Jackson Township

Zoning Commission

Rezoning **2-RZ-2024**
Applicant: Spartak Selmiaj
Property: 1696 Dyer Road, (parcel #160-000860)
Acreage: 10.05 acres
Utilities: Onsite Well and septic
Request: To amend Exceptional Use District

Elevations -
Exterior

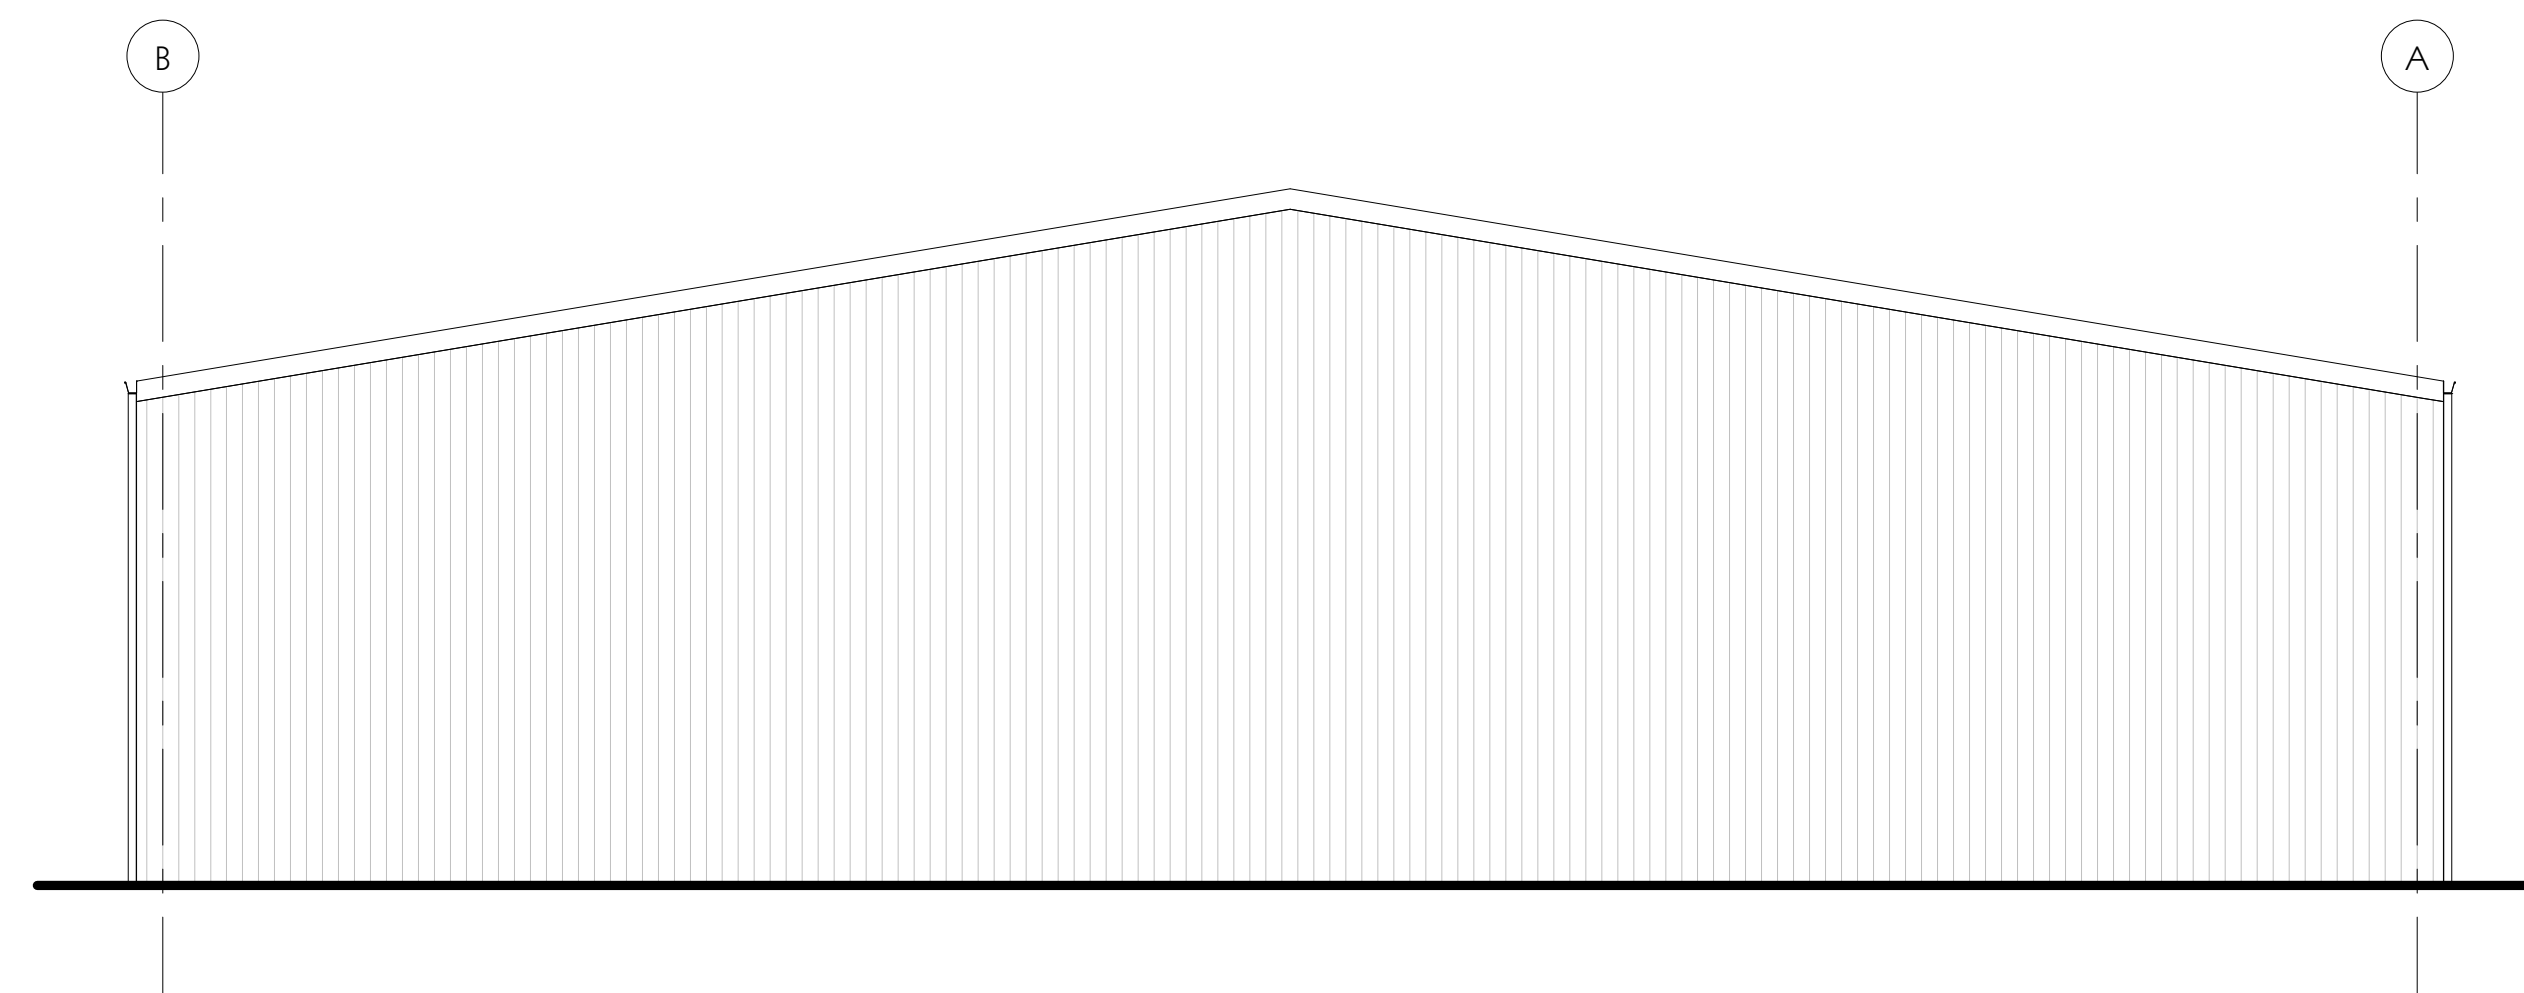
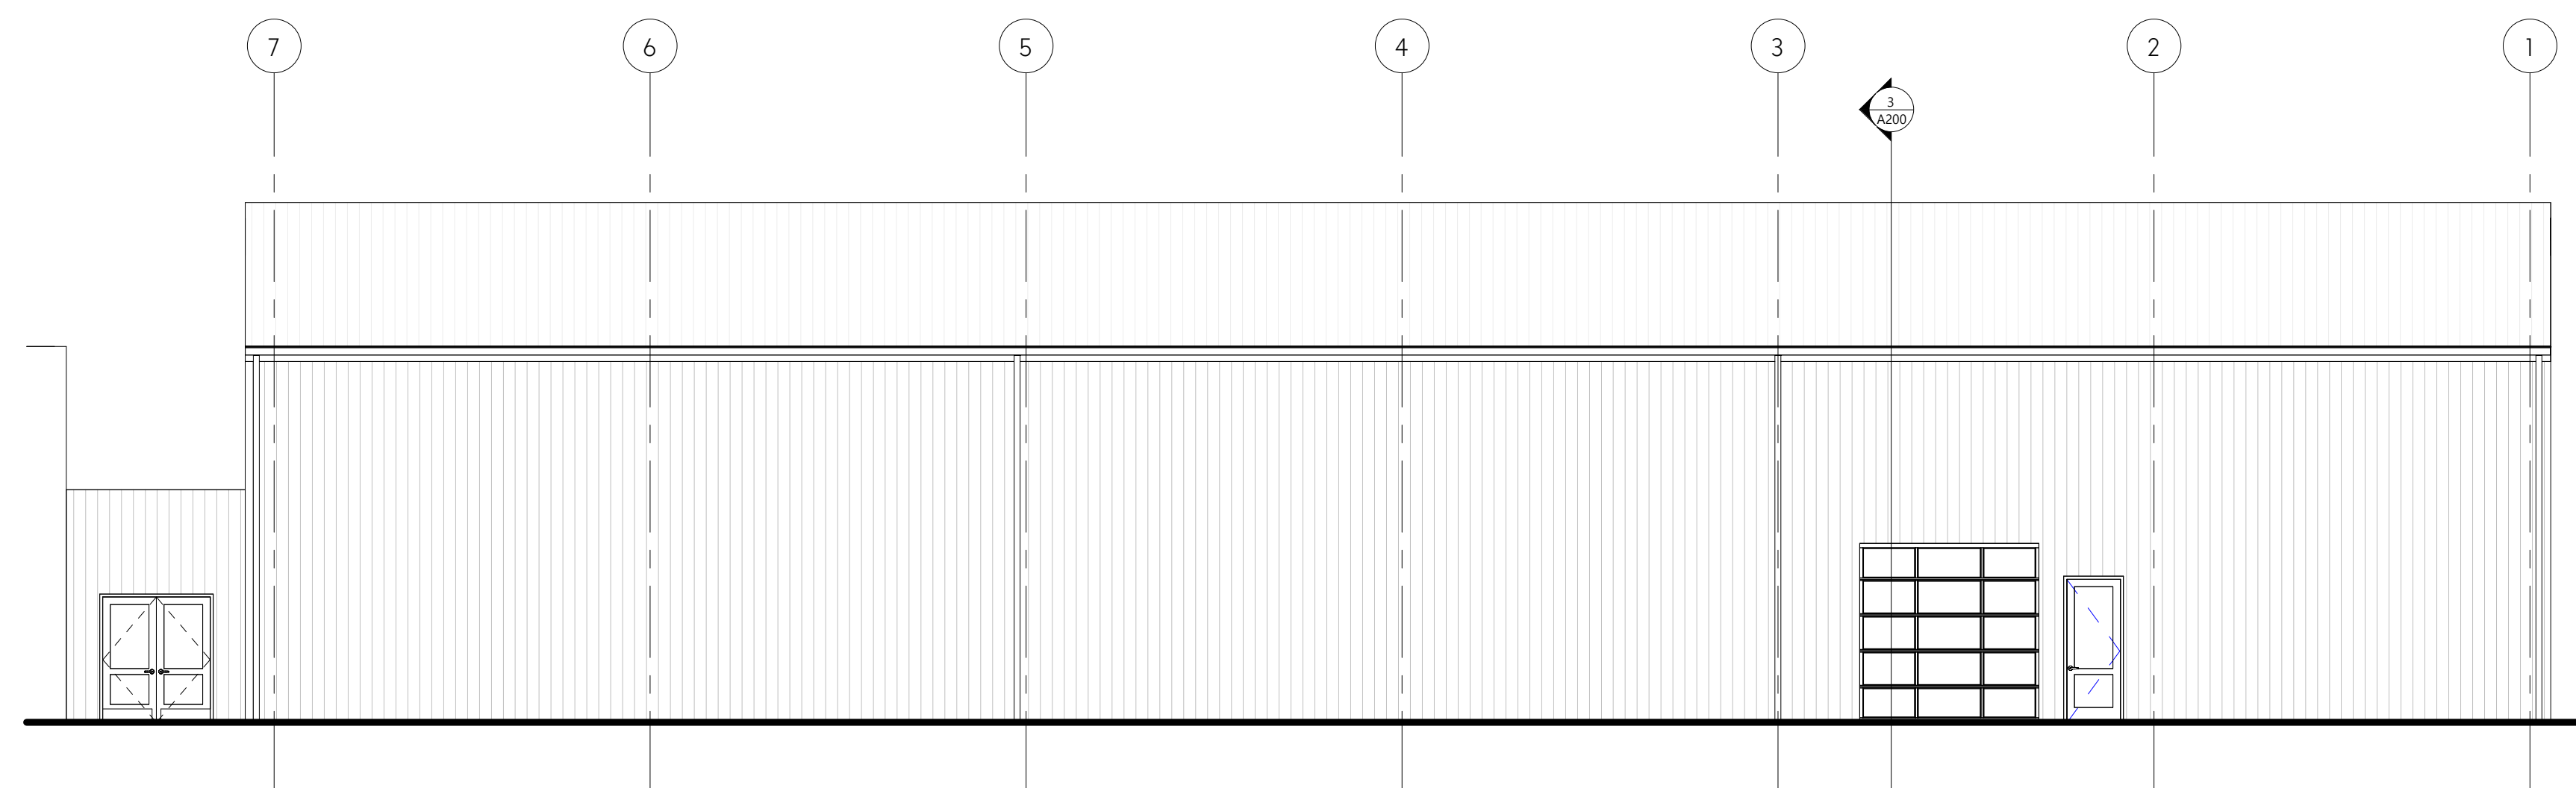
- b. *Elevation designs of the proposed buildings were provided. It is unclear the exterior design and color of the proposed buildings.*
 - c. *No statement of future land use of the area north of the proposed buildings.*
